Therma-Wave Floating Puck Upgrade for Opti-Probe OP5xxx and OP7xxx

Floating Puck Upgrade for OP5xxx and OP7xxx

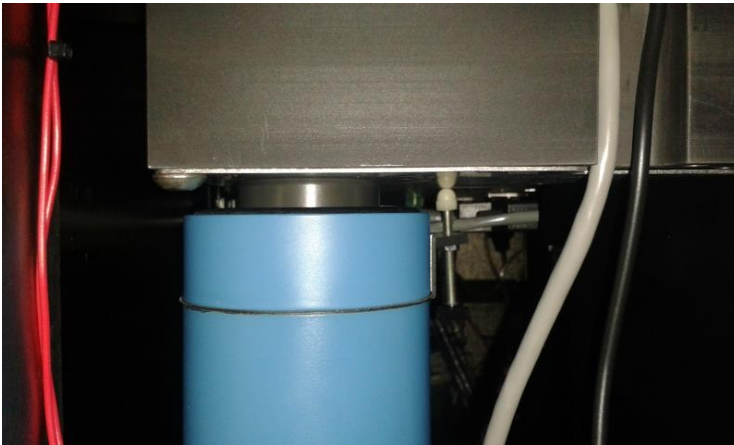
On Opti-Probe OP5xxx and OP7xxx there are chronic problems with Stage Docking

- Unbalanced and uneven pulling down of opticsplate
- Thereby higher consumption of diaphragm (P/N 290300-12 or P/N 59-084737)
- Rough and uneven docking may lead to instability
- Breakage of docking cable

The „Floating Puck upgrade kit“ includes 4 pcs Aluminium Pucks, which replace the original, screwed in pucks of the vibration cylinder.

1. Improvement of docking, becomes more reliable.
2. Balanced and even pulling down of opticsplate
3. No consumption of diaphragm resulting in lower CoO
4. Higher Uptime
